## Technical decision RRJ0000-OR-470-4950

on continued airworthiness of aeroplane RRJ-95 with deactivated EPAS system of entrance/service doors in automatic mode

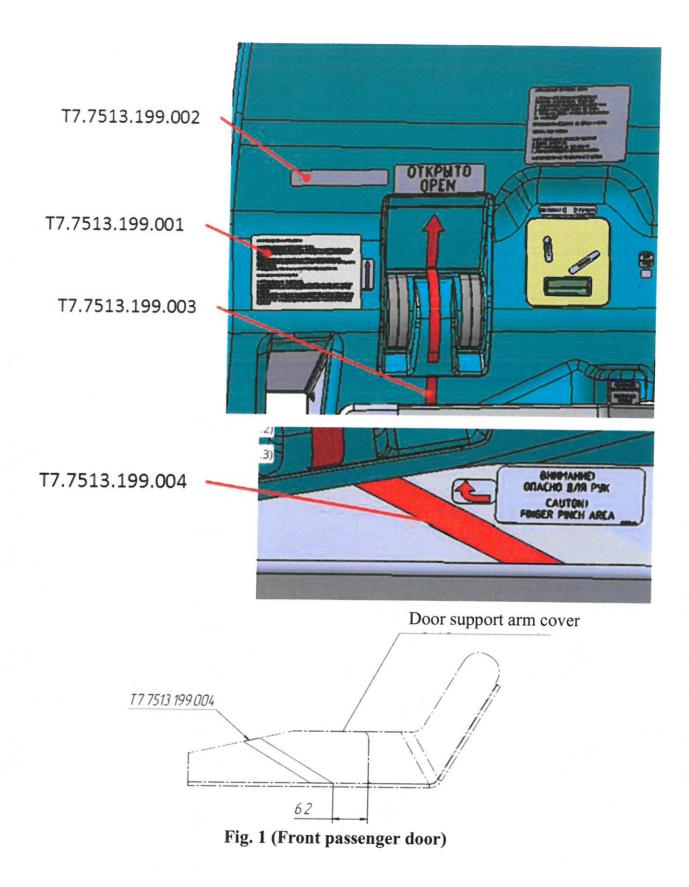
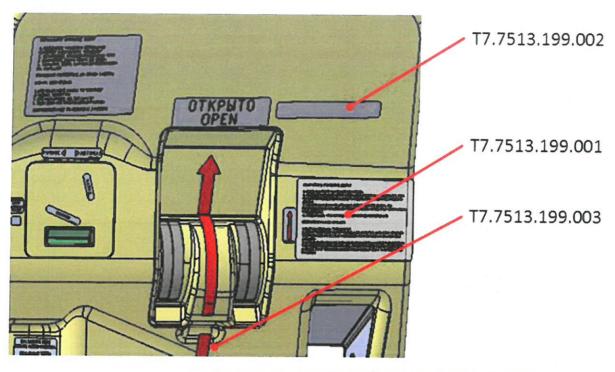
- 1. During nearest WY Check (8 days) on aeroplane RRJ-95 with door arms p/n A415406-001 Rev.E, A415406-003 Rev.E, A415406-005 Rev.E and A415406-006 Rev.E to install new and shift earlier installed placards: on front passenger doors (see Fig.1, Fig.4, Fig.5), front service door (see Fig.2, Fig.4, Fig.5) rear passenger and service door (see Fig 3, Fig.4, Fig 5) in accordance with AMM task 11-00-00-900-801 «Installation and removal of inscriptions»

Fig. 3 (Rear passenger and service door)

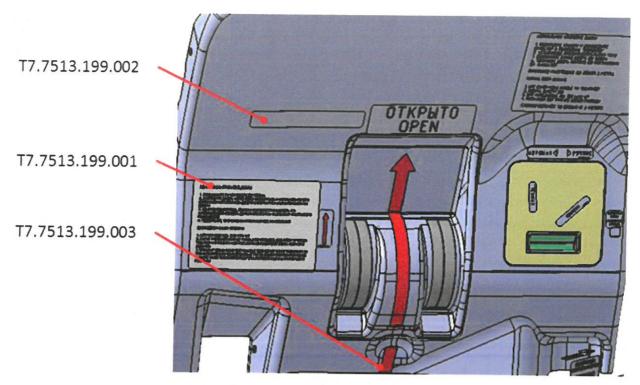
The installation of the placards
